Re: ETHAN ALLEN ADDITION
12521 Montgomery Blvd. NE
Approval of Permanent Certificate of Occupancy (C.O.)
Engineer's Stamp dated 12/30/2003 (F-22/D12A)
Certification dated 11/19/2004

Re: ETHAN ALLEN ADDITION, (F-22/D-12A)
12521 Montgomery Blvd. NE
Permanent Certificate of Occupancy Certification dated 10/20/2004

**Re: Ethan Allen Addition, 12521 Montgomery Blvd. NE, Grading and Drainage
Report**

RE: ETHAN ALLEN (F-22/D12A) ENGINEER'S STAMP DATED 9/21/94

DRAWING NO. 42 R2

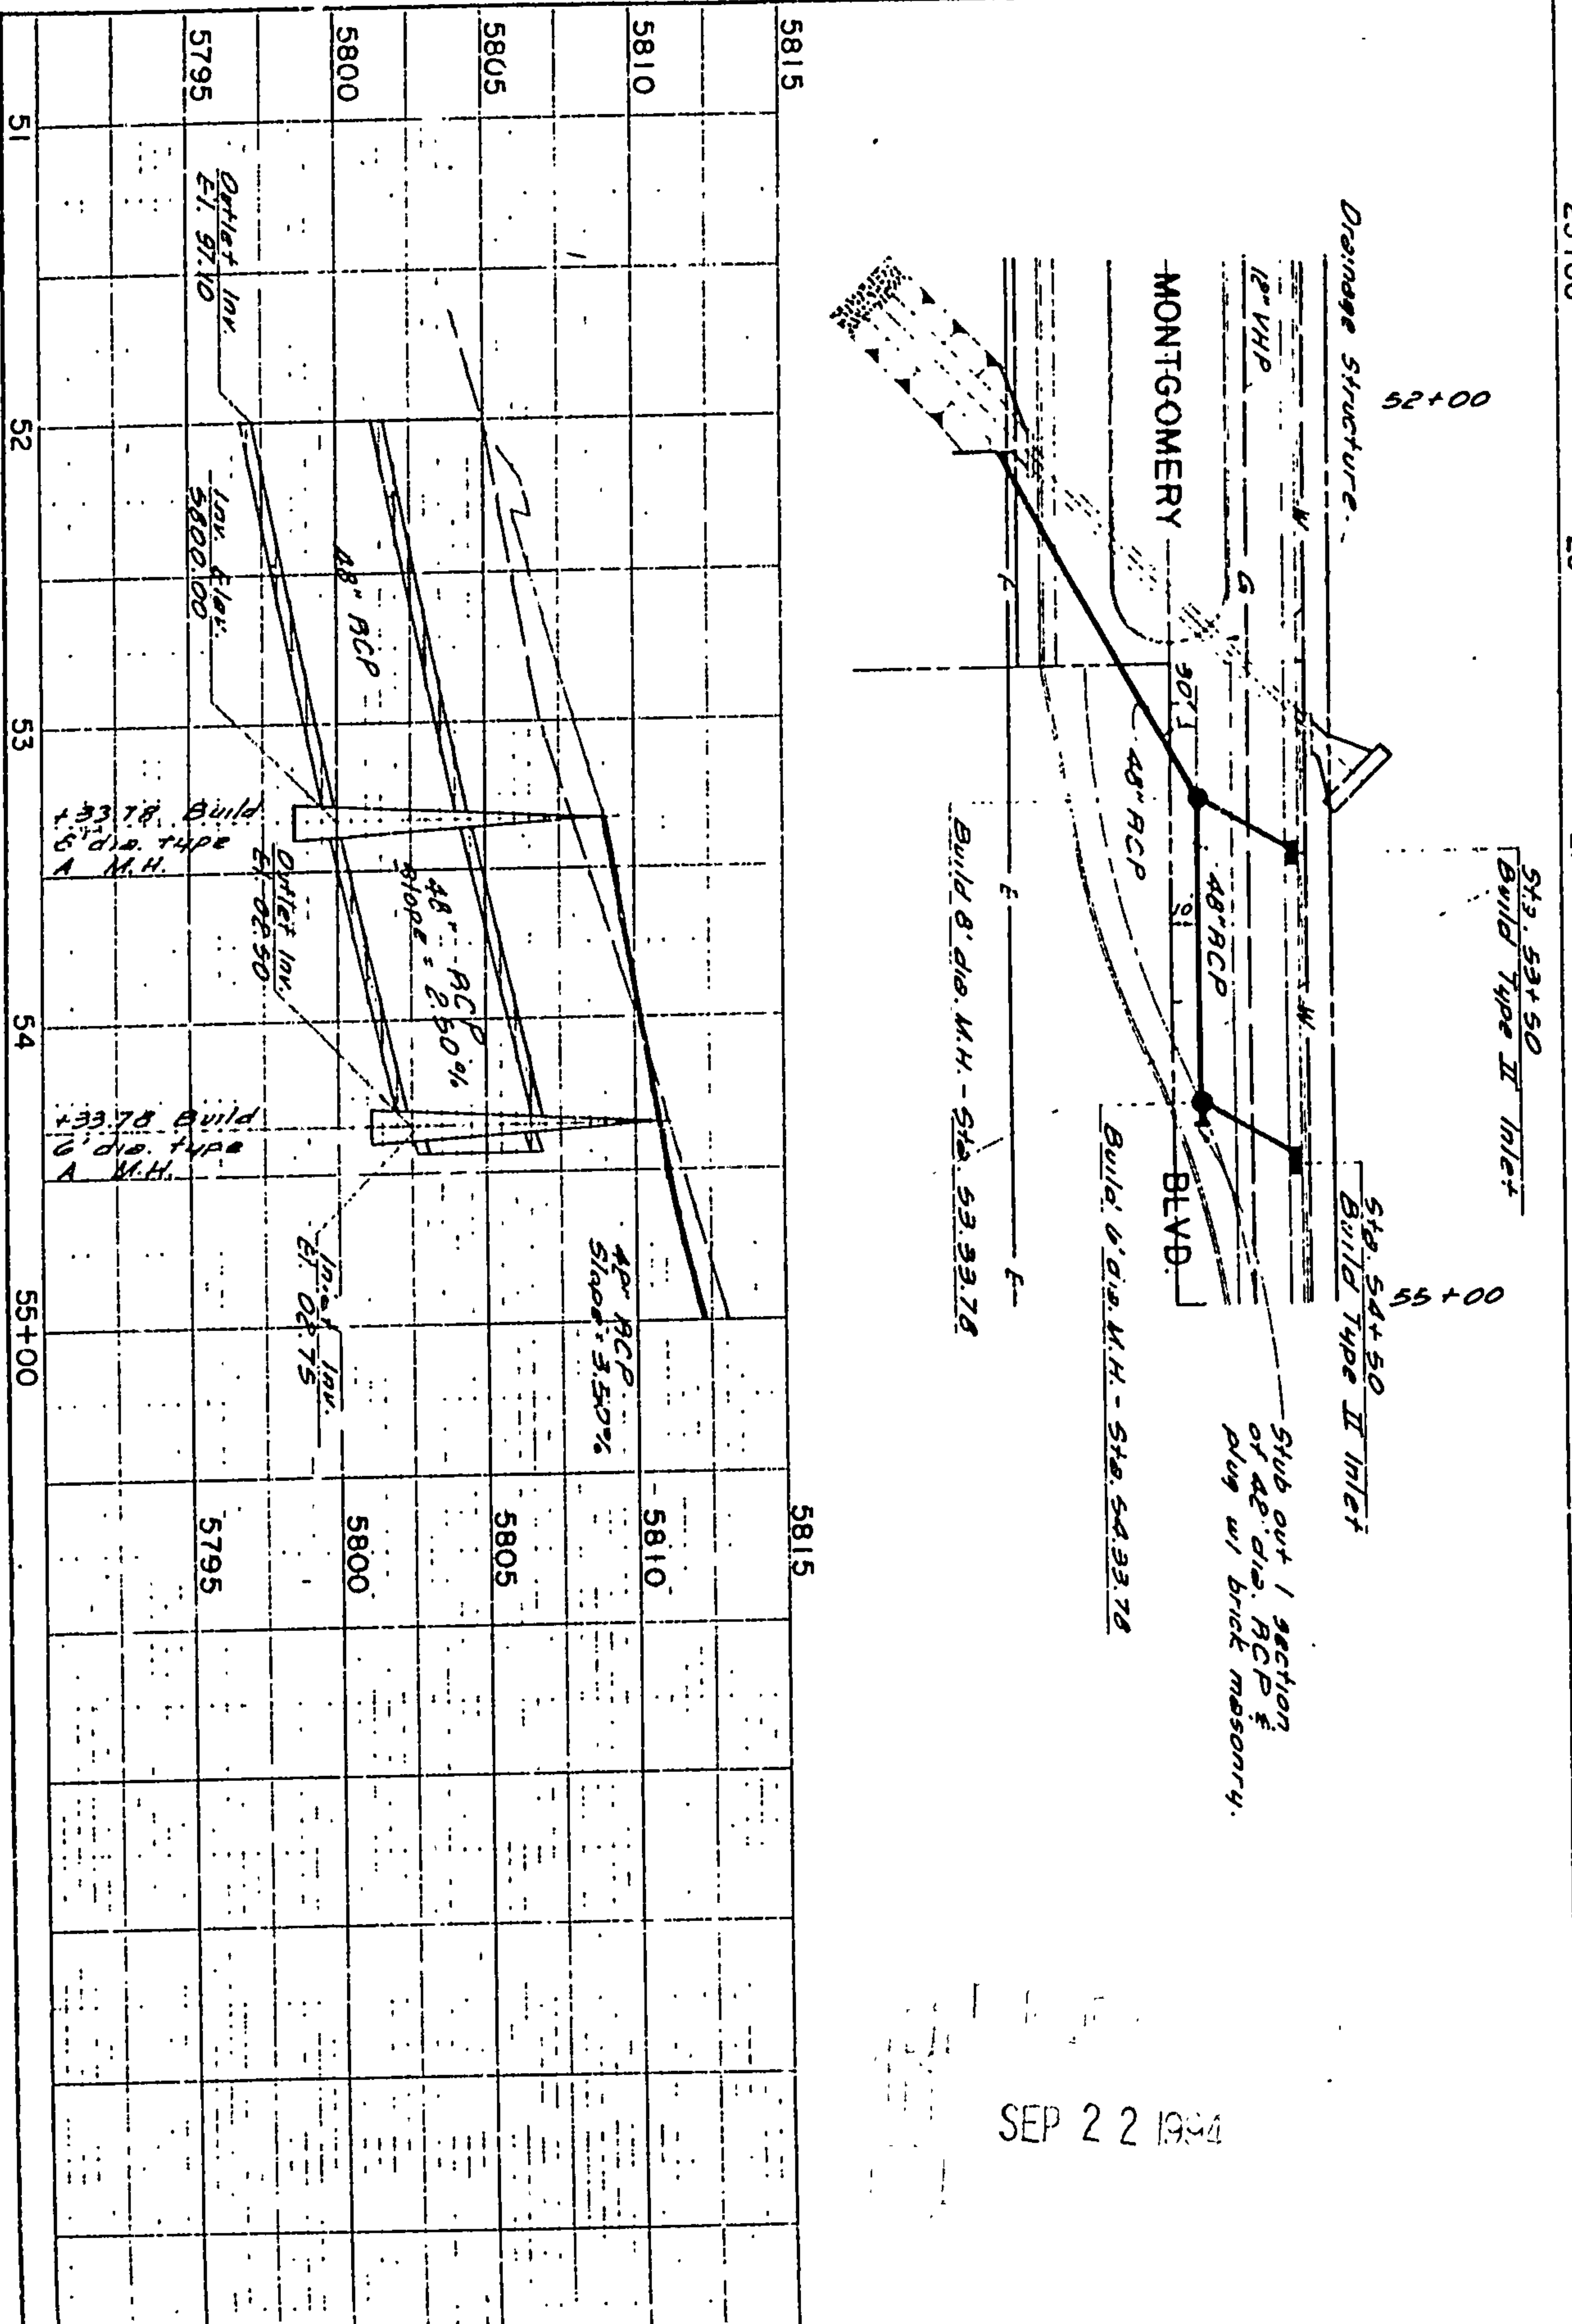
Re: Ethan Allen Grading and Drainage Plan, dated 9/21/94
